SB-983

SERVICE BULLETIN AMATEUR RADIO

SUBJECT MC-48B MIC ELEMENT CHANGE	DATE 02/06/91
--------------------------------------	------------------

MIC ELEMENT PART # T97-1024-08

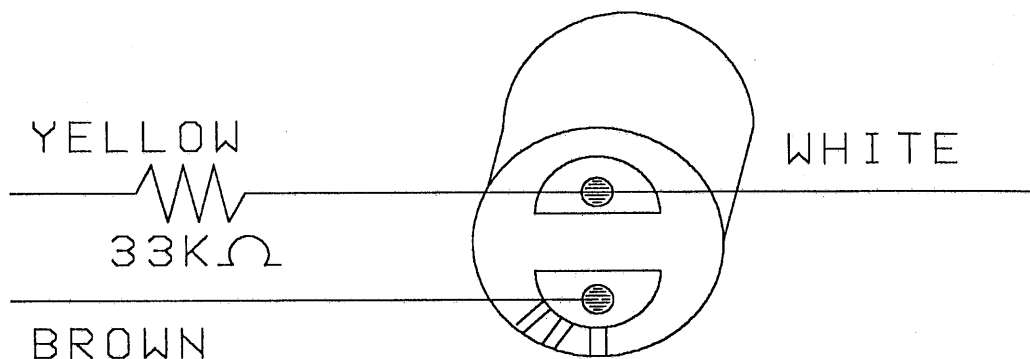
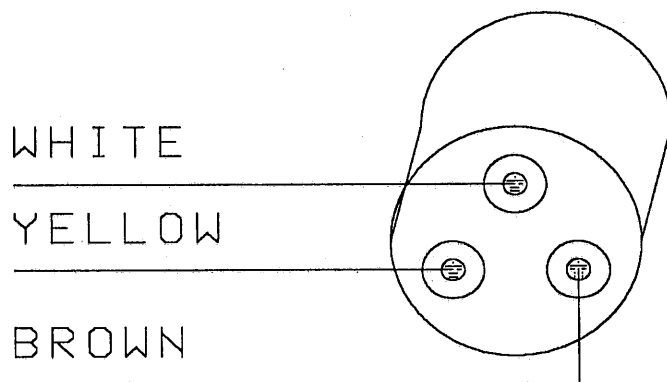
The original microphone element has been replaced. The new element has two connections and is much smaller than the original three connection element. When installing the new element, connect the wires as shown below. A 33K ohm, 1/4W resistor must be placed in series with the yellow wire. The rubber spacer is placed in front of the element when the microphone is assembled. The metal spacer can be discarded.
